Re: North Broward Resource Recovery Project, PA 86-22  
Request for Modification,  
Responses to Agency Questions

NORTH BROWARD RESOURCE RECOVERY PROJECT:  
REQUEST FOR MODIFICATION OF SITE CERTIFICATION  
PA86-22

RESPONSES TO FDEP QUESTIONS

**ASH RECYCLING PROCESSING FACILITY  
FLOW DIAGRAM  
NO SCALE**

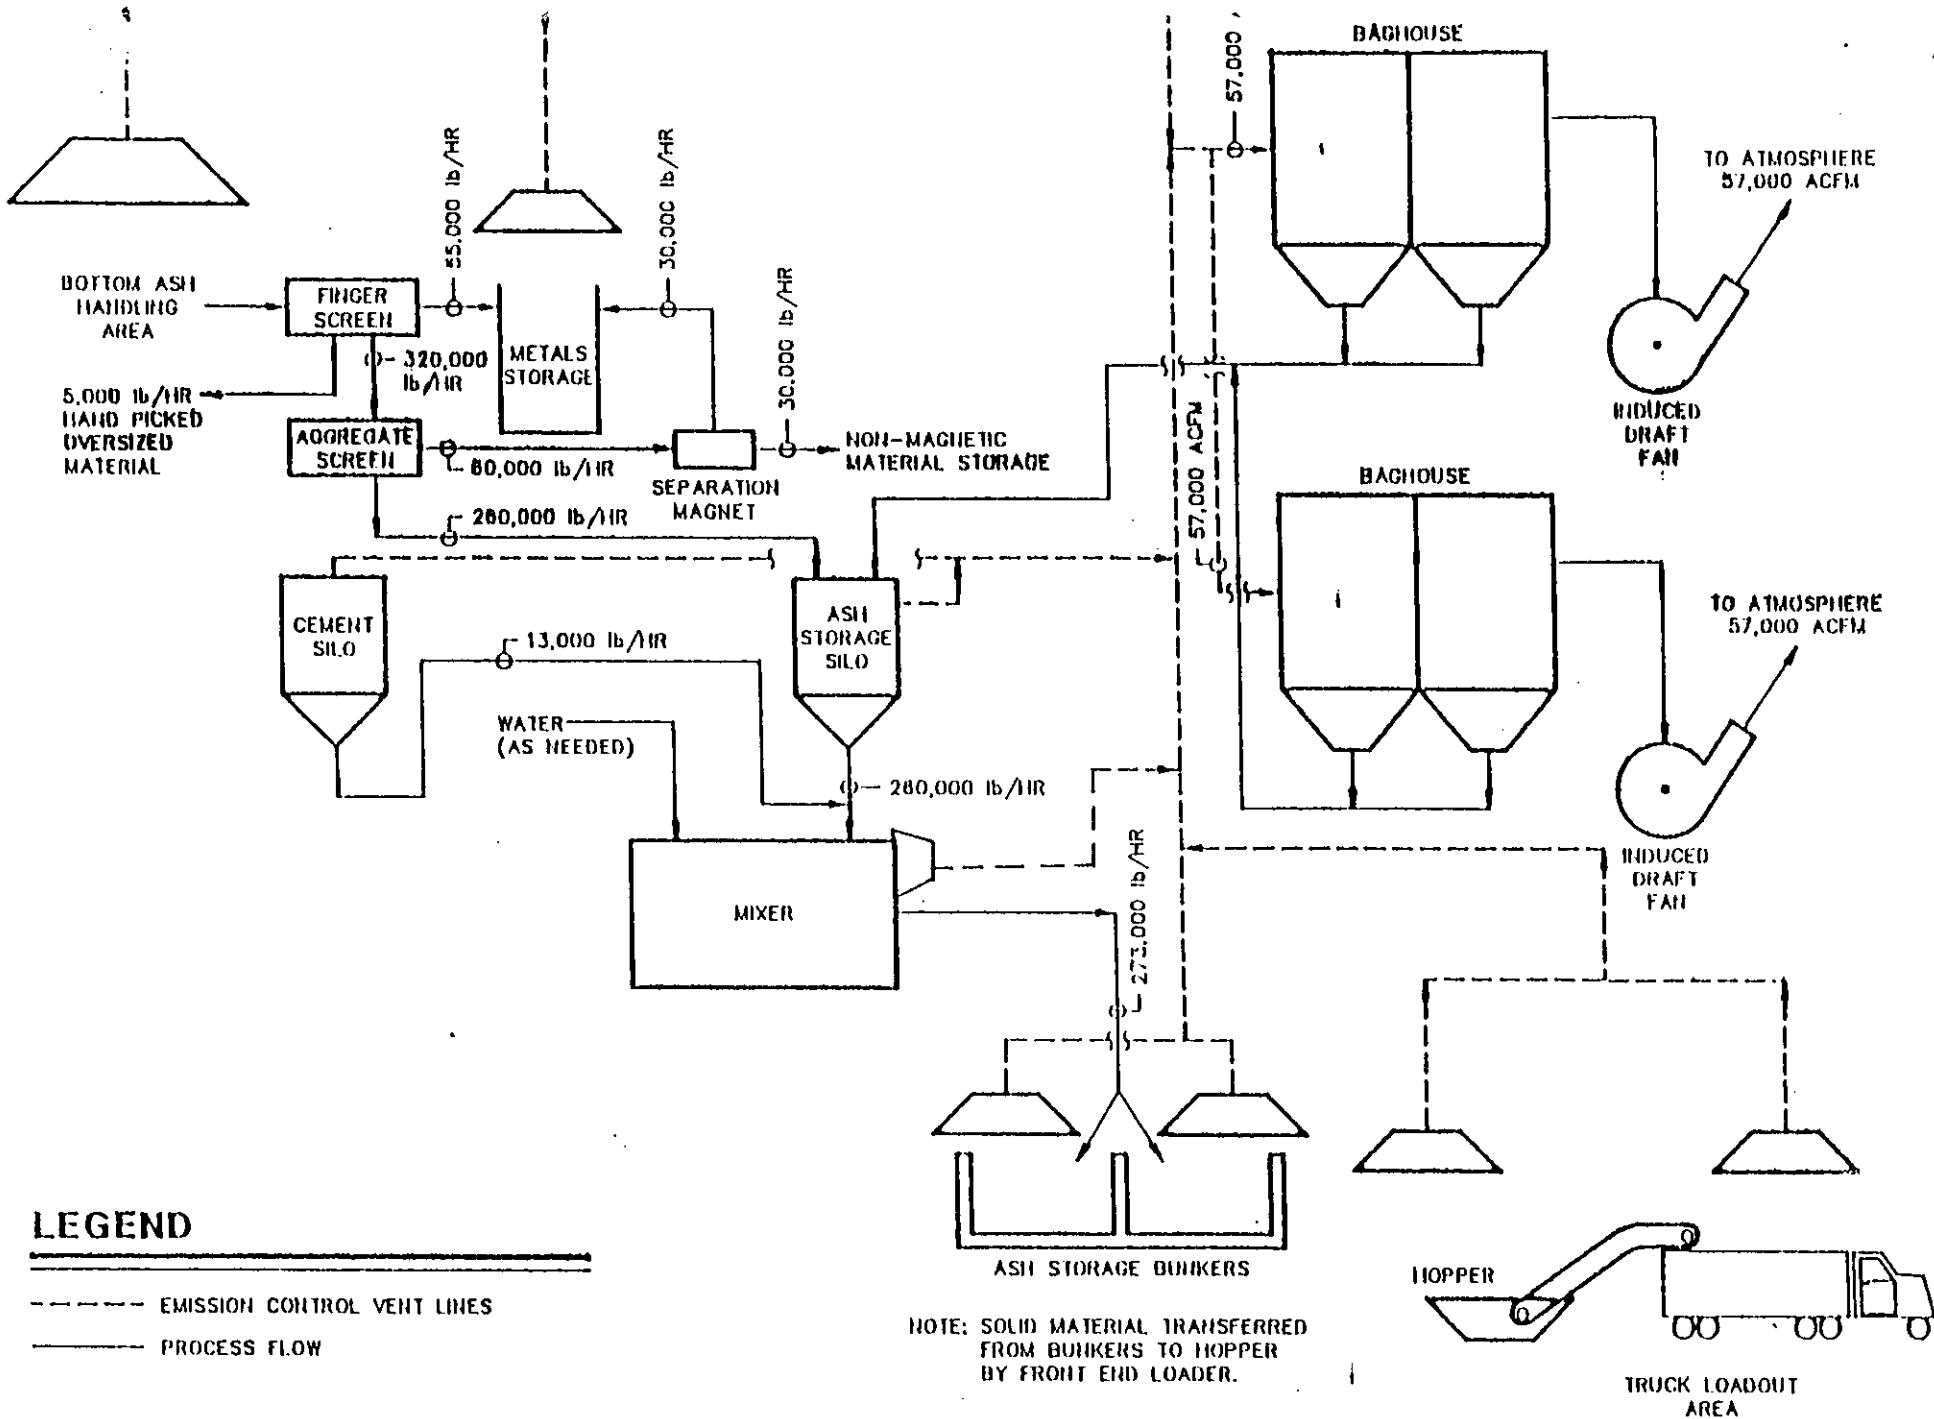
7. The downleg vent of the ash storage silo is identified incorrectly on the process flow diagram, the vent in question actually vents the mixer directly. A revised process flow diagram is attached.
